## Design Exception #3 Reducing the Buffer Area at MP 188 to 190

I-70 West Vail Pass Safety and  
Operations Improvements

**Issue Task Force Design Exceptions Meeting # 3**  
**August 2, 2021**

**Project Leadership Team Design Exceptions Meeting # 9**  
**August 6, 2021**

Exhibit A -  
Context Sensitive Solution  
Median Design Exception  
Mile Post 184.8 to 185.3  
07-26-2021

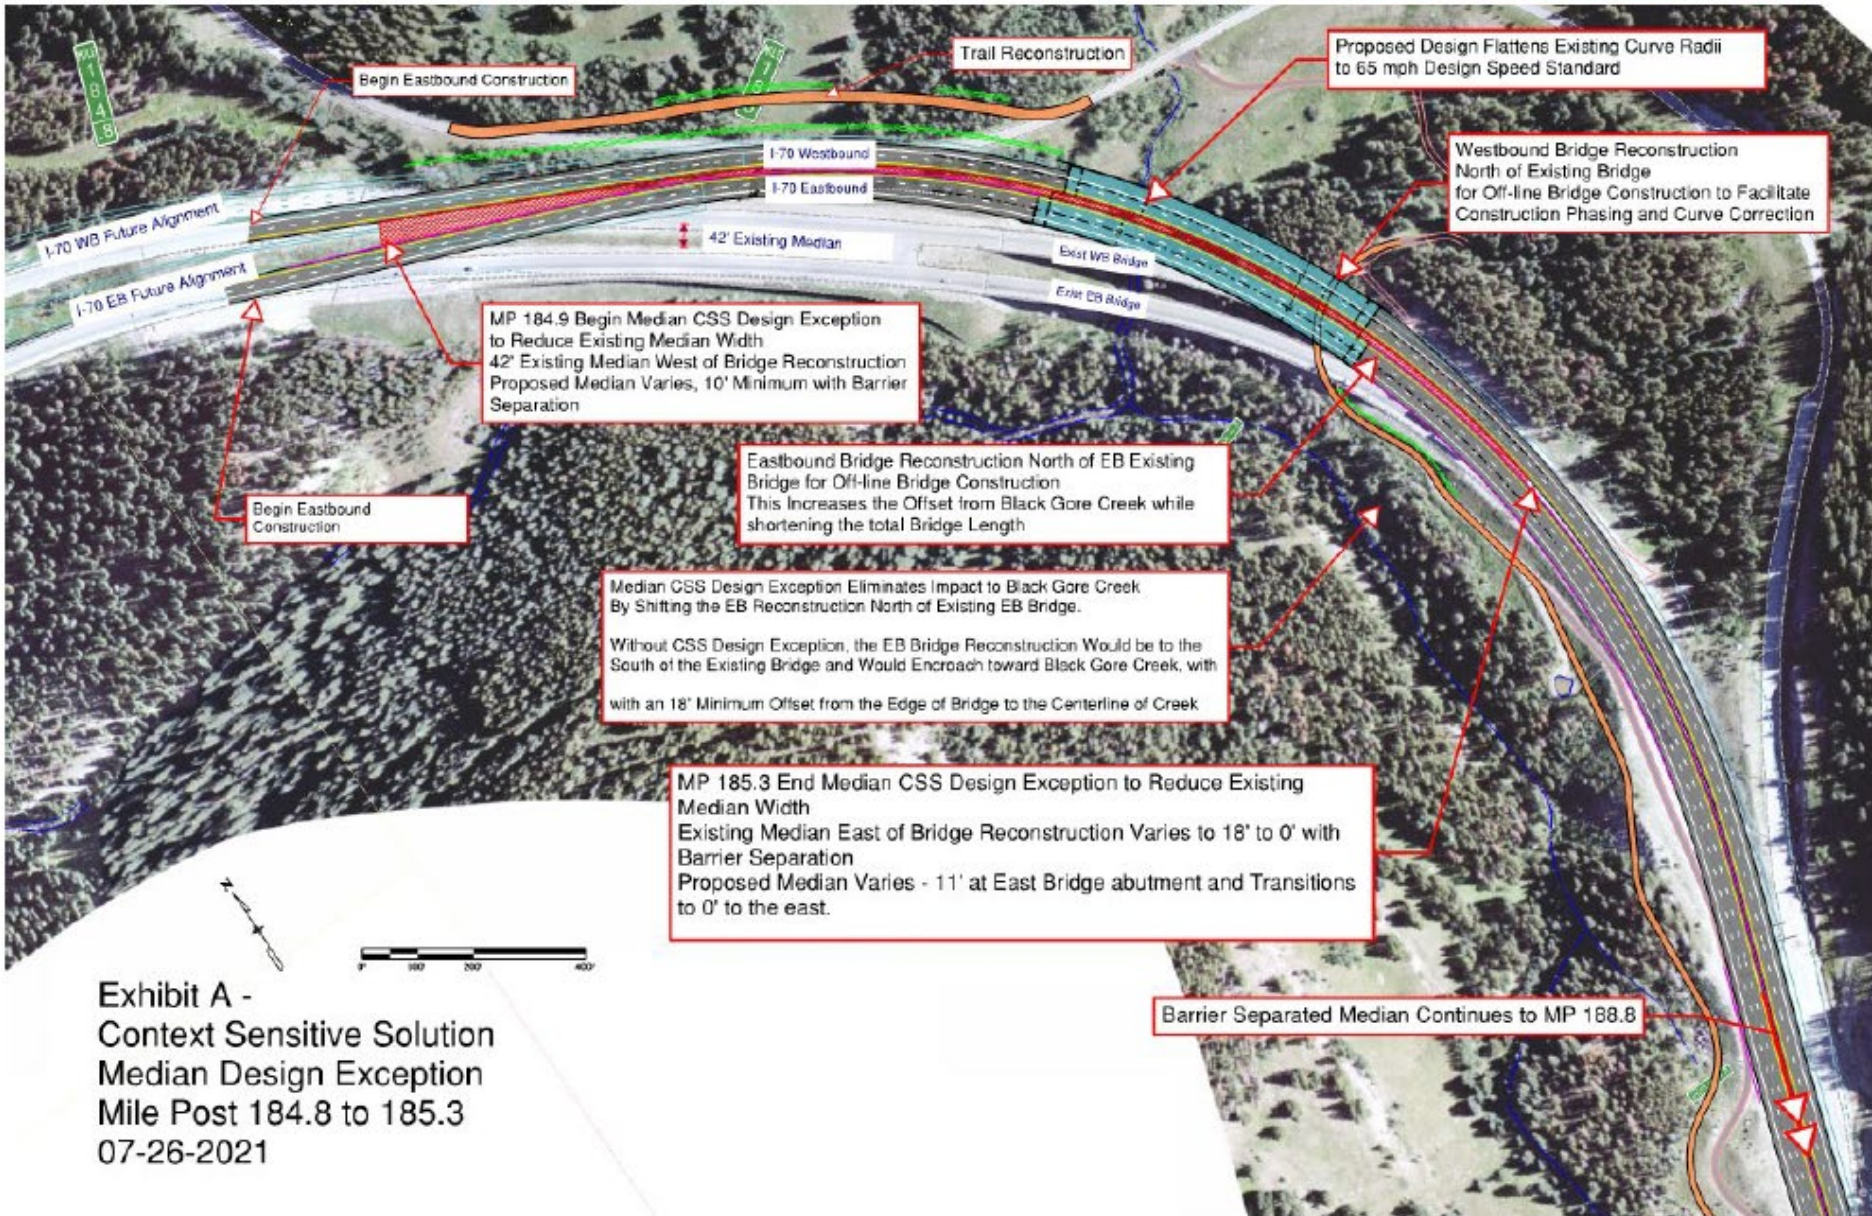
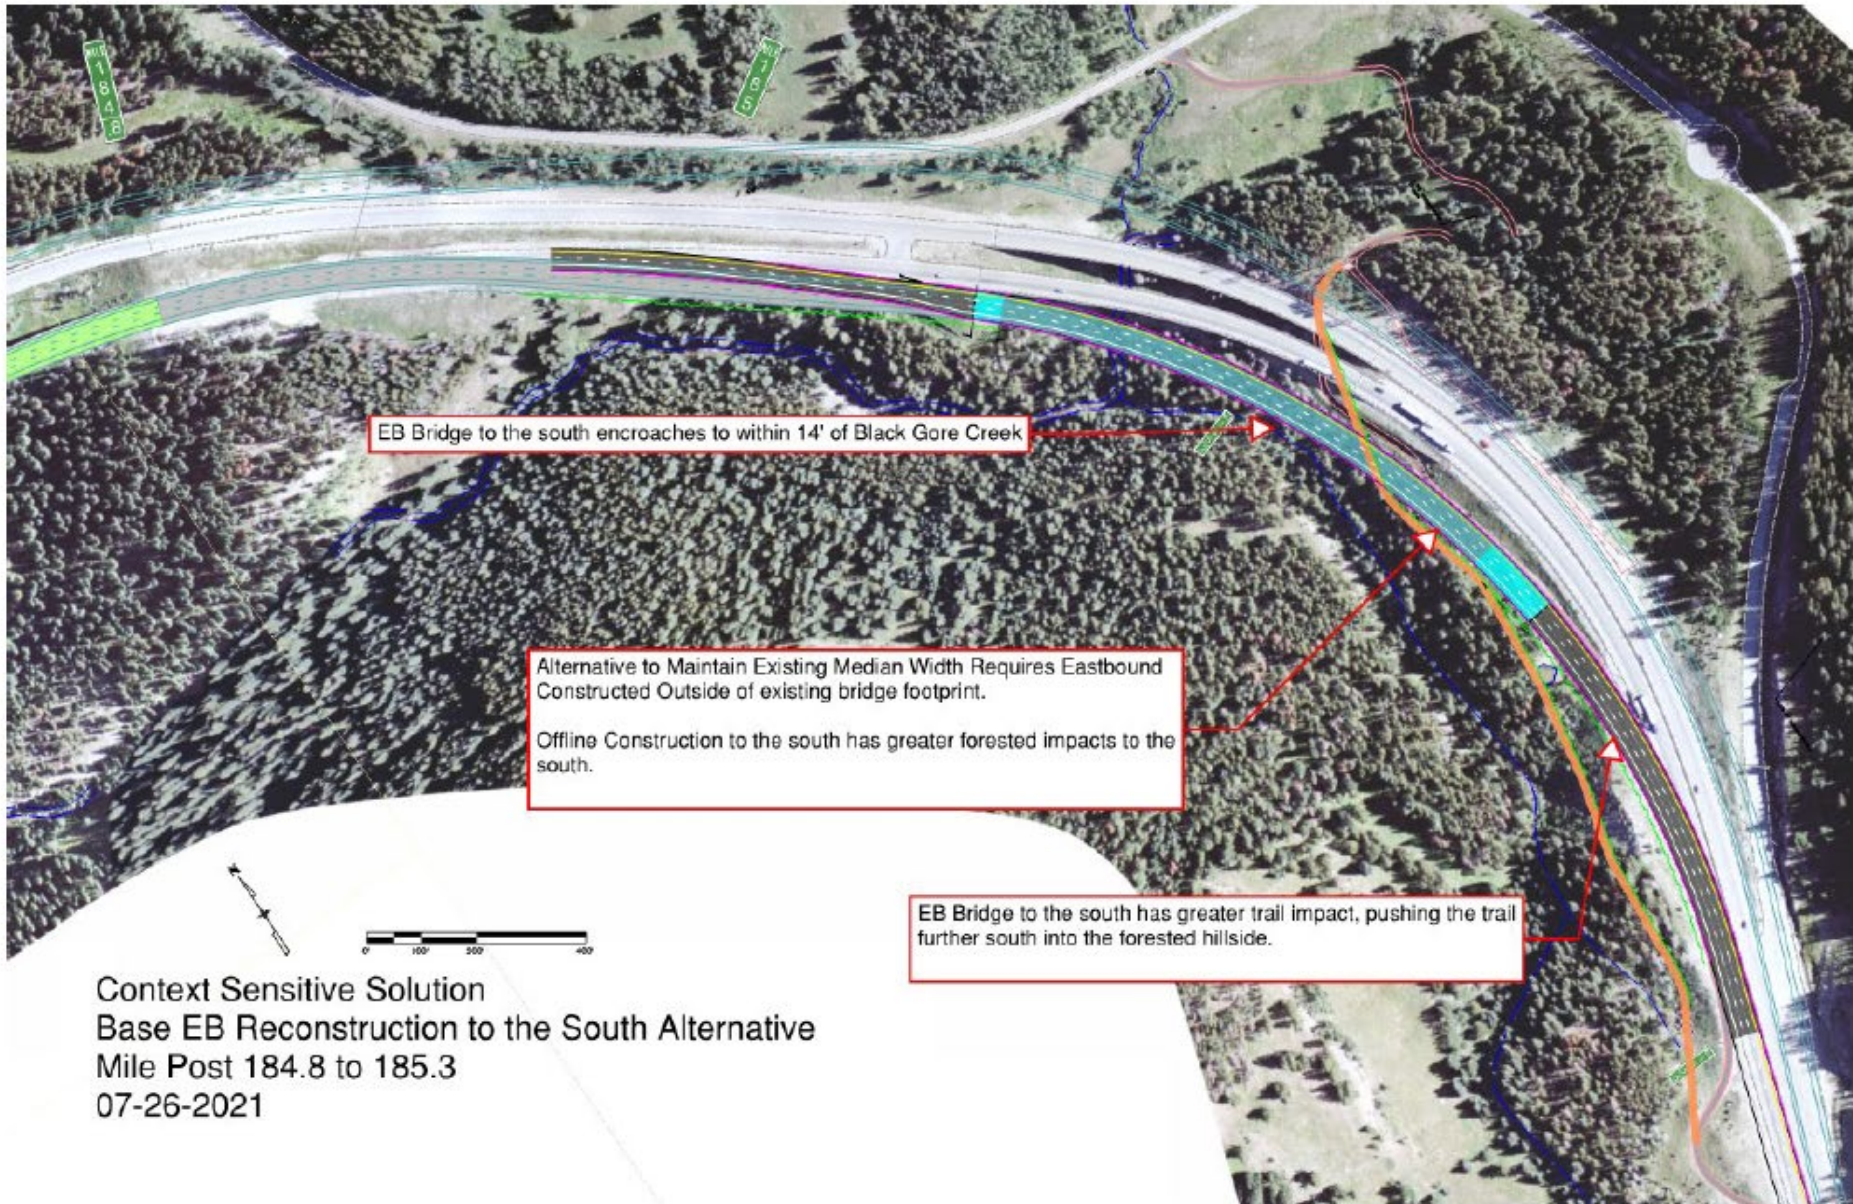
- a) Brian said the Design Exception from MP 184.8 - 185.3 EB and WB is the biggest change from the EA. The EA design just had the eastbound bridge reconstruction and we have revised the design to incorporate both an eastbound and westbound bridge. The EA design had impacts with a big existing fill wall outside of eastbound and it really chased the rec trail down the hill. It required a 1,200-foot bridge eastbound and was close to Black Gore Creek which was an environmental concern with how much snow is being thrown from the bridge. We spent some time looking at that design and came up with an option that provides the same amount of total bridge length but gets us both east and westbound bridges constructed by pushing them to the north and replacing 2 bridges instead of 1. By constructing the westbound bridge to the north, it is set so that it is offline from the existing. The constraint is the east side of the existing westbound bridge and trying to maintain the existing truck ramp. We corrected the curve significantly to provide curve radius that meets 65 mph design speed. It does push us out into hill into the US 6 side on the north side. There really wasn't much room to move the westbound bridge. Once that westbound structure is out of the way, the eastbound can be reconstructed towards the median offline. And that really helps to pull the eastbound away from the hillside, Black Gore Creek and helps out from a grading standpoint significantly from the EA option.

To make eastbound fit we need to have two continuous lanes of traffic through construction, therefore we have to reduce the median width between the two bridges. The existing median is 42 feet and we are reducing that down to be a barrier separated median. This is very close to the original intent of as the rest of the section is closed median barrier and this just extends it for ¼ mile to allow us to balance the impacts and pull eastbound well off of the existing

- ii) Greg said the westbound bridge was going to be wide enough, but it would be tight to run two-way, two lane traffic on it while you are building the eastbound bridge. It looks like now you are trying to keep your existing eastbound continuing the traffic after the westbound is built which is a little bit of a difference in constructability.

- iii) Greg asked if there is a gap between the two bridges or is it going to be one really wide structure?

- iv) Greg asked if you could pull the eastbound bridge a little further to the south on the westbound end of it. The reason why the original designers had the gap was for aesthetics to save the trees between the bridges. They're all dead now but it was a very distinct quality to have vegetation from down below coming between them. It would be good to make them not be so close together.

- iv) Greg asked if there is an opportunity to start with 10 feet as you go across there to diverge that eastbound just a bit instead of having continuous 10 feet all the way through. Could you start the curve uphill a little sooner and then flatten the curve?

Brian said the new bridges are not wide enough to have the two lanes of traffic with two-foot shoulders to maintain a proper MOT section. If we were to widen out the bridge enough to have that head to head traffic we felt there were safety concerns with a long construction cycle of having 11-foot lanes and 2-foot shoulders at a curve that is maxed out for 65 mph design speed. This option has traffic on the existing bridge until the new bridge is completed and we're maintaining the full lane and shoulder widths other than the pinch points at the very east end for the full cycle of the bridge construction.

Brian said there is a gap. There is a profile difference where they need to gap, about 8 feet between bridges at the minimum and somewhere between 8 feet and 12 feet for the entire way. They pull away from alignment as they go to the west and as they go east they get a little closer.

Brian said our constraints were really tight there so for us to be able to keep the phasing option offline it required the gap to be that small and there was no room to expand it any further.

Karen said the thing Brian is trying to balance there is the existing bridges have a substandard radius which leads to a high crash rate in this area. He's trying to hold that geometry to reduce crashes and bring it up to standard. That is what is triggering the alignment in this area. We don't want to tighten that curve to what is like out there now that is causing crashes.

Exhibit B -  
Context Sensitive Solution  
Median Design Exception  
Mile Post 186.9 to 187.4  
07-20-2021

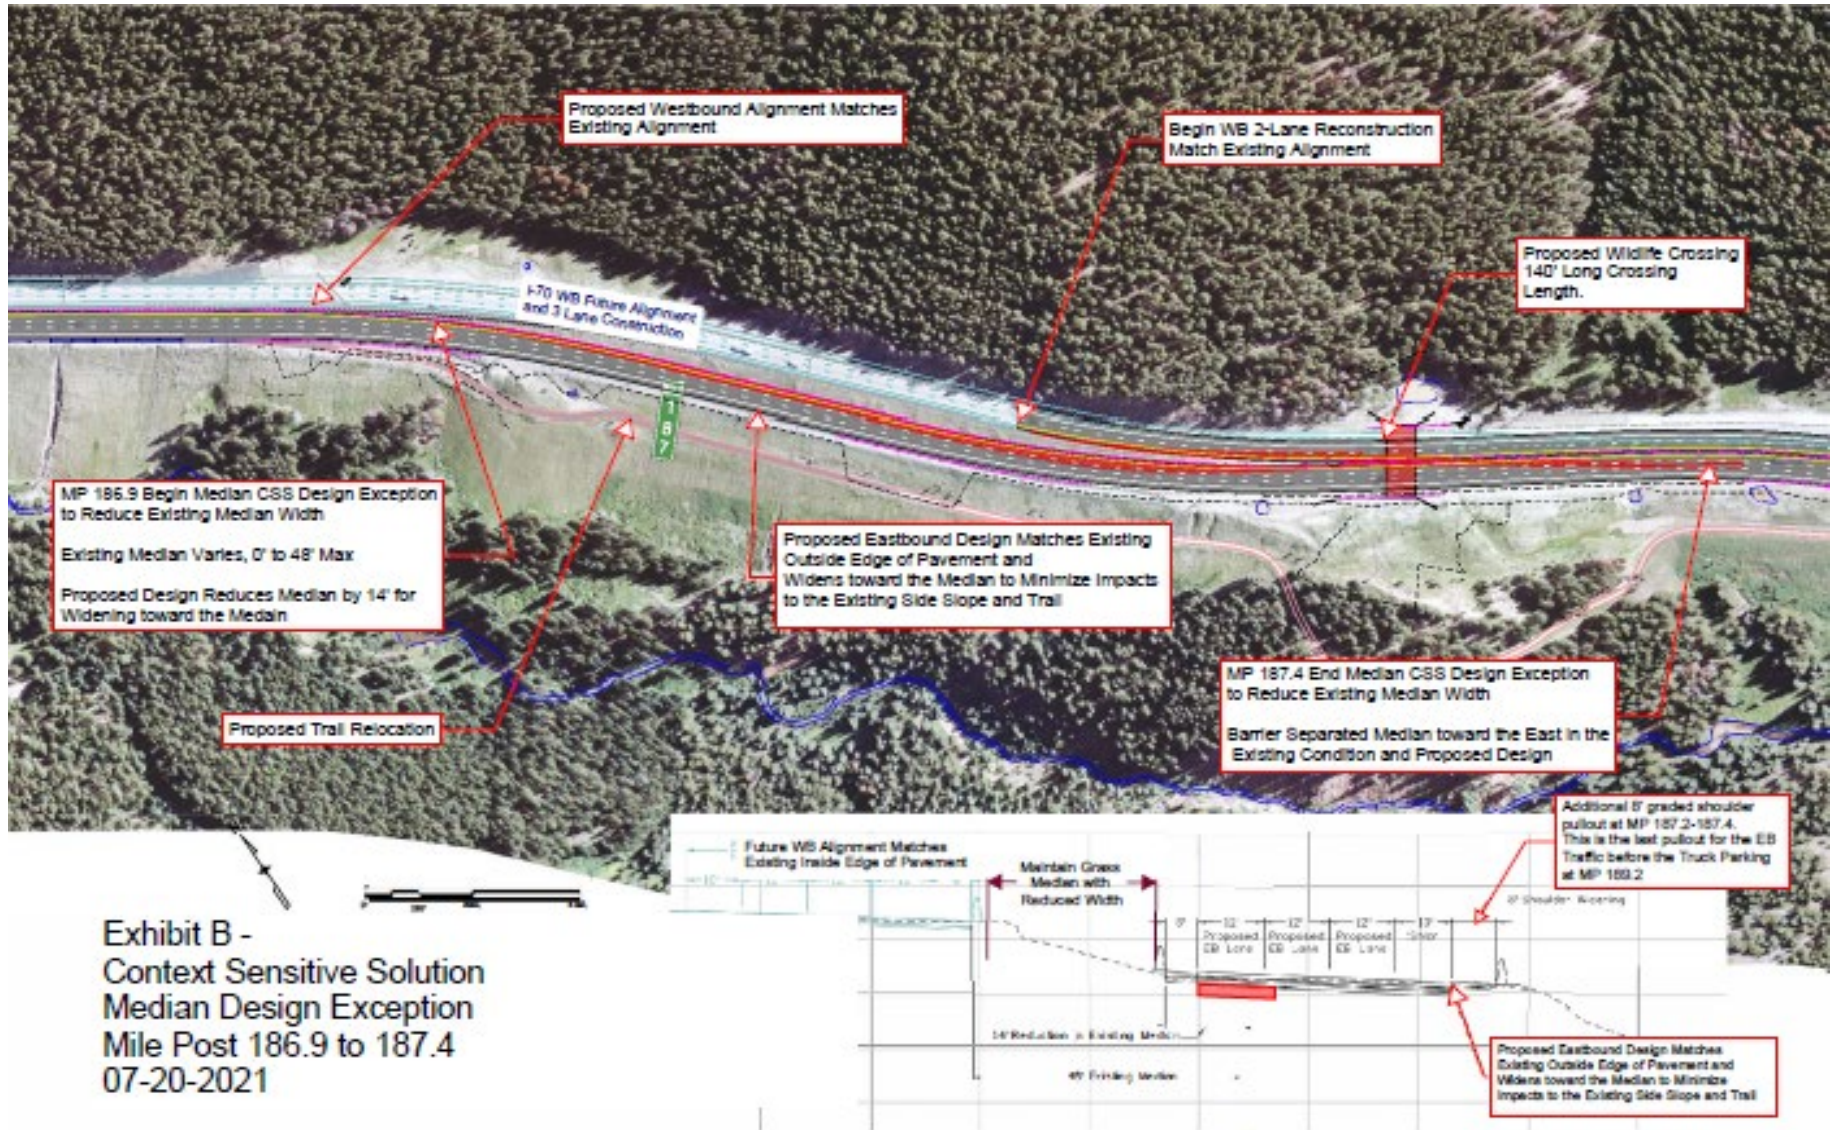
- a) Brian said this is just north of the cut walls we talked about earlier. There is an existing open median for a short duration in between the curves. The EA showed this as a completely closed median. The design exception we are asking for here is within the reversing curves where there is a short section of open median. We are trying to balance impacts to the forested slope to the north you can see how dense that is with the steep hillside going down to the south or west here on the eastbound and down to the trail it is a relatively steep slope.
- b) In the EA there is a section to the west where we have the existing median with the scallop walls. We are pulling that in to eliminate the space for the 15 feet of scallop wall. With our design we kept the alignment the same and matched the existing inside edge to the west through that existing median wall.

i) Greg said you would have 14 feet but no walls?

ii) Greg inquired where the AGS alignment go through in this area? There is one spot where they do cross. Having to cross at a very skewed angle the structure is going to get very big. But if you have at least 14 feet that is probably big enough to put a pier in between. However, if they did need to cross it would be something you need to look at.

Brian said we would match the existing walls to the west and it will just be grading and barrier in the median.

Brian said this will not preclude the AGS alignment. There is more than 14 feet through this area so there should be plenty of room for an pier or details if they need to cross.

Exhibit C (2 of 3)-  
Context Sensitive Solution  
Median Design Exception  
Mile Post 188.8 to 190.1  
07-20-2021

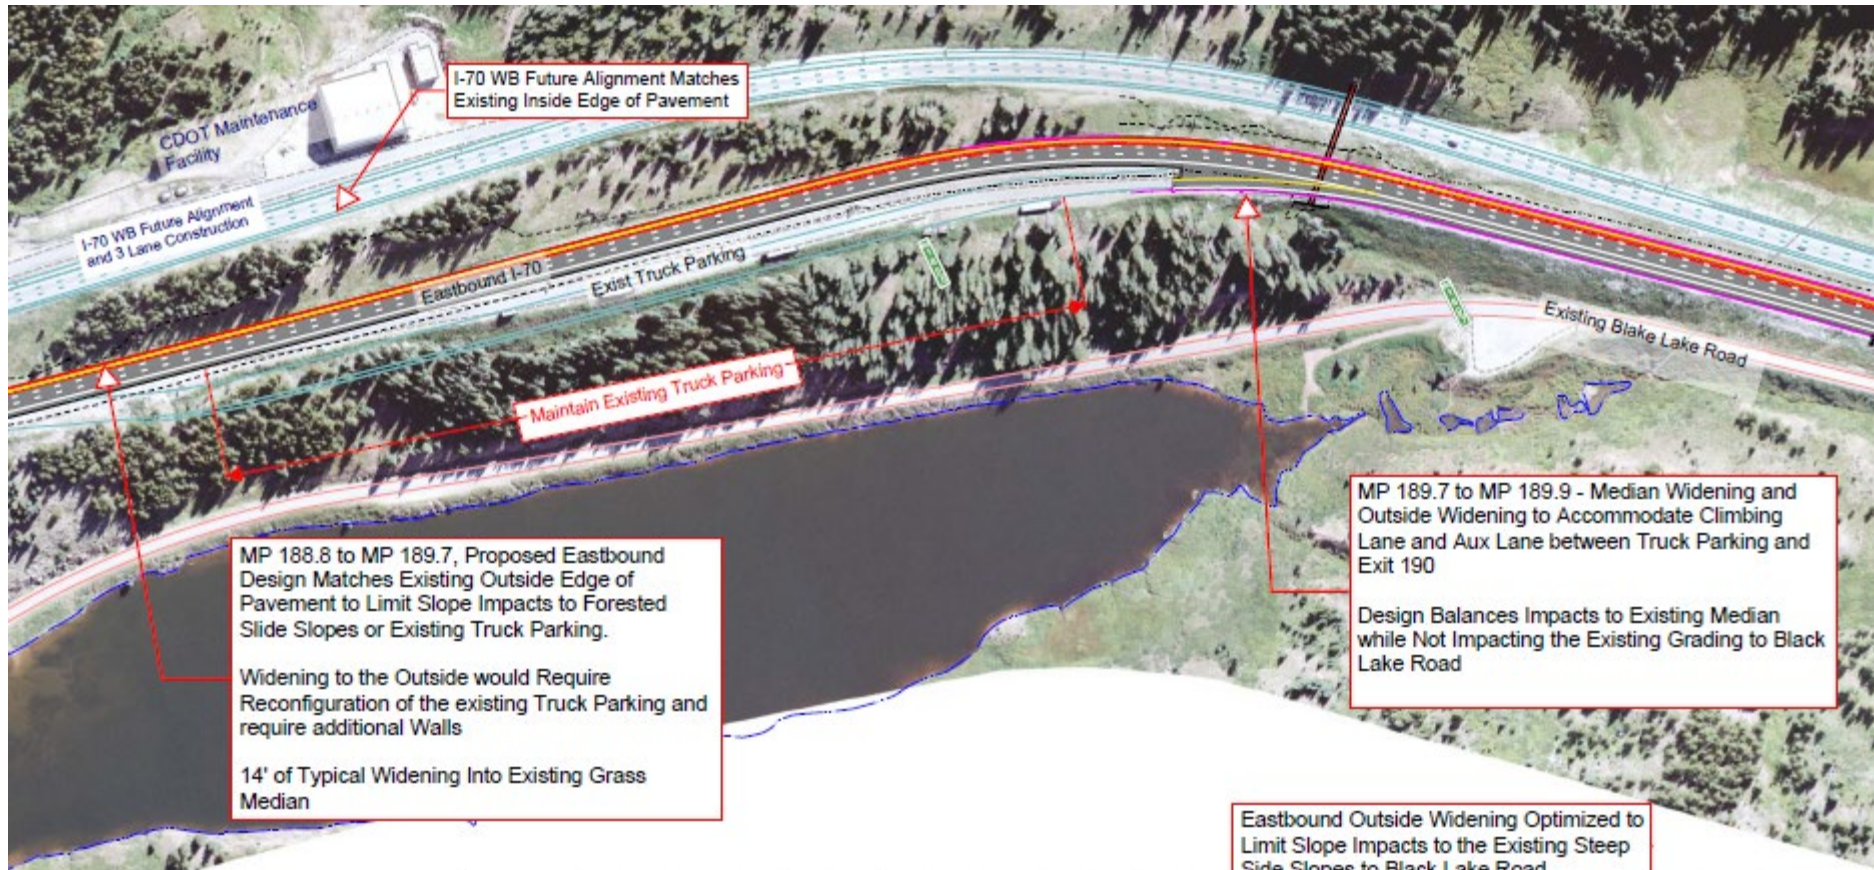
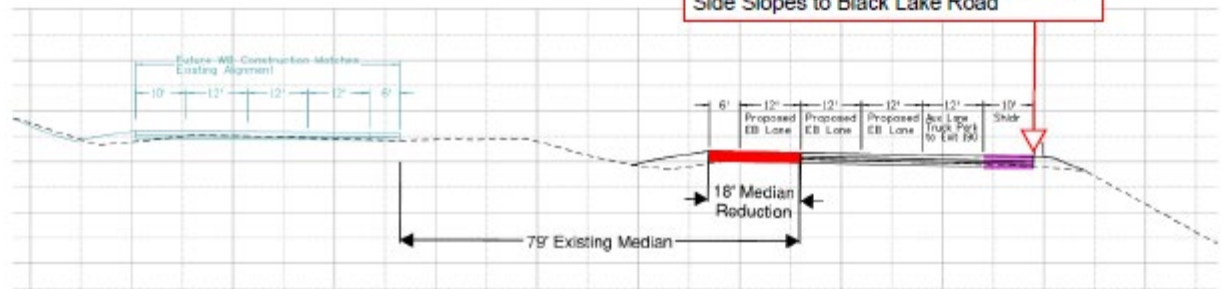
- a) This design exception is to extend the limits of the EA design to accommodate the aux lane from the truck parking to MP 190. The EA showed just a rough exhibit of where the climbing lane terminated. When we went through a more refined design what started to stand out is that it made sense to have a continuous aux lane between the truck parking on-ramp and the Exit 190 off ramp which extends the median widening all the way up to Exit 190. We are still able to maintain the existing grass slope and not have a lot of additional concrete barrier in this section so it should have the same relative feel but just widens to the median.

- b) We are matching the existing outside edge of pavement and widening 14 feet into the median is consistent with the roadway geometry. This alignment allows the existing truck parking to remain in place. The outside of the eastbound slope chases a steep hillside and forested slope so through here the optimal design is to widen to the inside to try to minimize our impacts into the trees. The truck parking on-ramp existing slope from the eastbound to the

- i) Mary Jo asked back where the truck parking is, since you are widening now maintains that, does it also offer an opportunity in the future to where the new planned truck parking may not have as high of walls?  
Brian said this is very close to the EA alignment and truck parking.

- ii) Greg said in that area going uphill, you're able to do all the widening going into the hillside and there will be no cut walls?  
Brian said they are trying to coordinate that with drainage to make sure we have our cut fit section done correctly and it provides adequate drainage. Since this is at the high point of the pass the ditch doesn't require a ton of capacity. It will really be about maintaining a clear zone ditch as much as it is about capacity of the ditch. Right now, with the survey we have it looks like we will be able to make this work with just grading and a barrier but no actual cut walls.

- iv) Michelle said she didn't see any of the wildlife crossings identified at 188.7, 189 or 189.6.

Brian said they are there, they just aren't called out because he was trying to highlight the roadway.

Karen said Michelle made a good point and these design exceptions will make the crossings shorter which is better.
